**SUBJECT:** Contract No. DE-AC07-05ID14517 — Next Generation Nuclear Plant Project Submittal — Response to Nuclear Regulatory Commission Request for Additional Information Letter No. 002 Regarding Next Generation Nuclear Plant Project Fuel Qualification and Mechanistic Source Terms — NRC Project # 0748

NGNP Response to NRC RAI Letter No.002

**Request for Additional Information No. 5772 Revision 0**

Figure 1. Description of the THTR NATE Sensor System

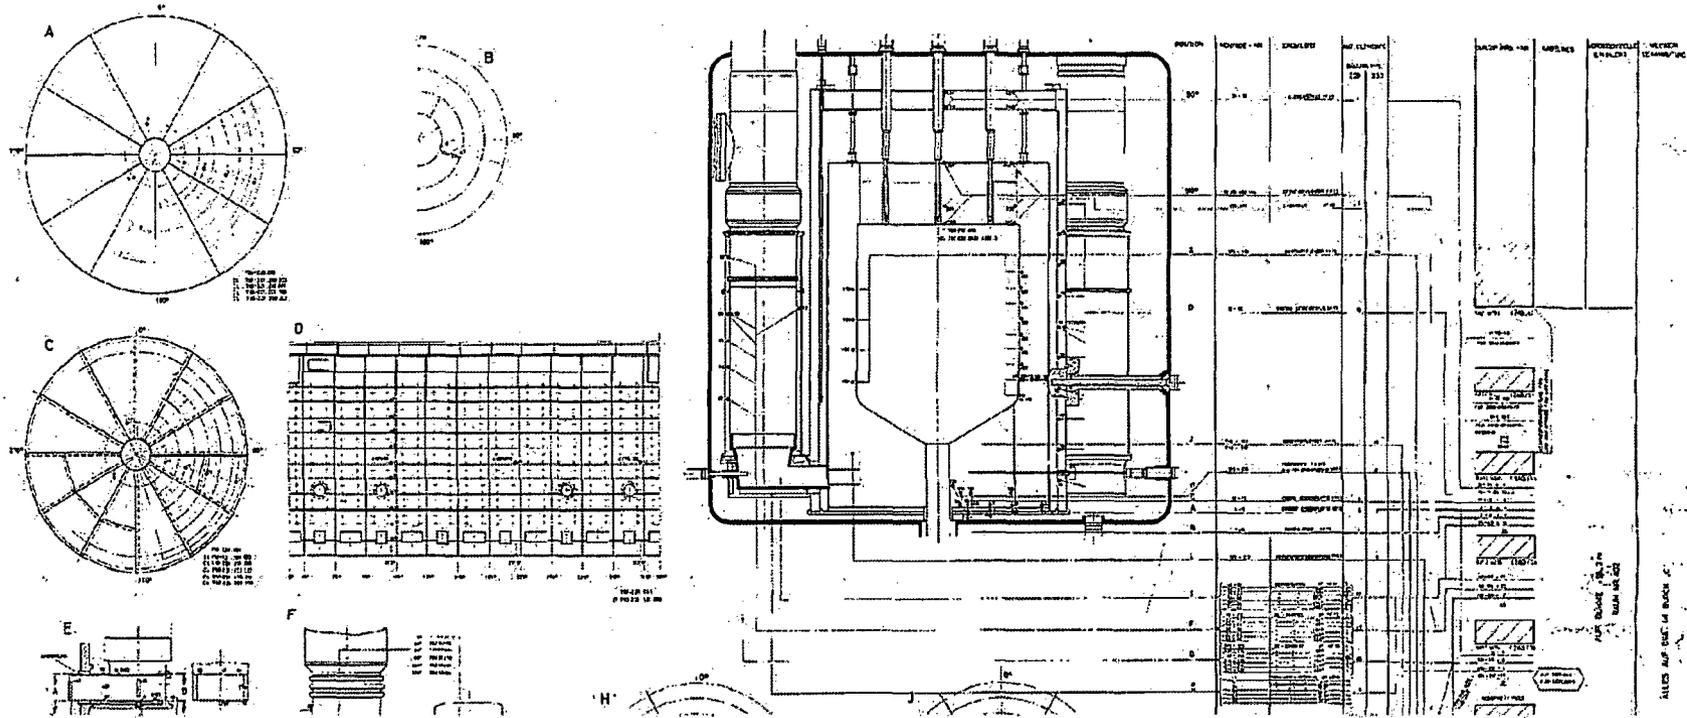
<sup>9</sup> Note: Please provide a reference that describes the THTR’s “NATE” sensor system and its use to monitor temperature profiles in the bottom reflector, as mentioned in [H. Kalinowski, July 2001].

Among the footnotes to the comments that accompany this RAI was a request that the NGNP Project provide a reference that describes the Thorium High Temperature Reactor (THTR) "NATE" sensor system and its use to monitor temperature profiles in the bottom reflector, as mentioned in [H. Kalinowski, July 2001]. Prior to receipt of this RAI, the NGNP Project had no information on the NATE sensor system. Upon further investigation, it was learned that [H. Kalinowski, July 2001] is a handout attached to an NRC trip report that is filed under the NRC's Agency wide Documents Access and Management System (ADAMS) under accession number ML092250104. The report is for a trip to Germany taken by NRC staff in 2001 to review various topics related to pebble bed HTGR safety. The reference cited is a handout for a presentation by Dr. Helga Kalinowski on startup testing at THTR. The handout includes a handwritten drawing that shows a plan view of the locations of the NATE sensors at the bottom of the reactor.

"NATE" is a German acronym for "Nicht-Autauschbare Thermo-Elemente", which in English translates approximately to "nonreplaceable temperature sensor element". These were hard-wired sensors that were located in THTR throughout the reflector (side and bottom) and at the inlet to the SG bundles. They were thermocouples that were designed as special commissioning instruments. Should they fail to function during the plant life, they would be left in place and would not be replaced since they were not needed for the operation of the plant. These sensors could be read into a computer at a press of a button to record the temperatures. This was done during the start up at 40, 60, 80 and 100% power.

Figure 1 is a page from the "THTR Shift Supervisor Training Manual – Metallic and Graphite Reactor Internals - Document Number CU0025". It includes a brief description of the NATE sensor system. The document is in German. Figure 2 is another drawing that shows the location of the THTR NATE sensors.

**Figure 1. Radionuclide Design Criteria**

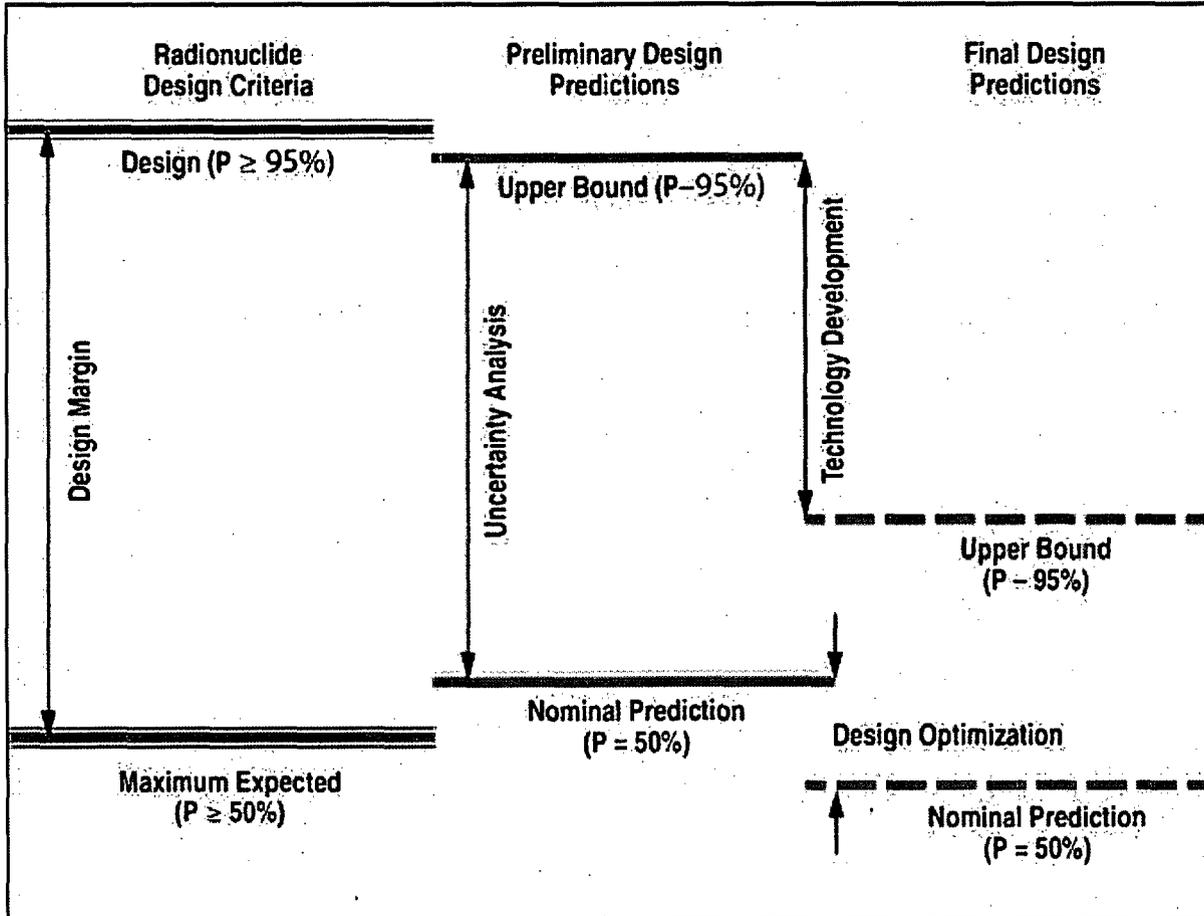
**RAI MST-87:** Please explain Figure 2-5 more clearly in terms of examples of how it would relate to a proposed mechanistic source term calculation.

Standard design practice in the U.S. HTGR program has been to define a two-tier set of radionuclide design criteria—referred to as Maximum Expected and Design criteria—for allowable core releases for normal operation and Anticipated Operational Occurrences (AOOs). This practice has been followed since the design of Peach Bottom Unit 1 and Fort St. Vrain up through the design of modular HTGRs. The Design criteria are derived from externally imposed requirements, such as site-boundary dose limits, occupational exposure limits, etc. Once the Design criteria have been derived from the radionuclide control requirements, the corresponding Maximum Expected, criteria are derived by dividing the Design criteria by an uncertainty factor, or design margin, to account for uncertainties in the design methods. This uncertainty factor is typically a factor of four for the release of fission gases from the core and a factor of 10 for the release of fission metals from the core (see response to RAI MST-62 for further discussion of these factors). The fuel and core are to be designed such that there is at least a 50% probability that the fission product release will be less than the Maximum Expected criteria and at least a 95% probability that the release will be less than the Design criteria. The GA approach to implementing such radionuclide design criteria is illustrated in Figure 1, which is a reproduction of Figure 2-5 from the

Mechanistic Source Terms White Paper provided for easy reference. No particular scale is implied in this figure; it is simply a conceptual illustration of the approach.

These radionuclide design criteria have multiple uses in plant design and licensing. First, they provide a figure of merit for judging the acceptability of candidate core designs. Secondly, they allow the plant design and safety analyses to proceed while the core and fuel designs are being optimized as the overall plant design evolves through the conceptual, preliminary, and final phases.
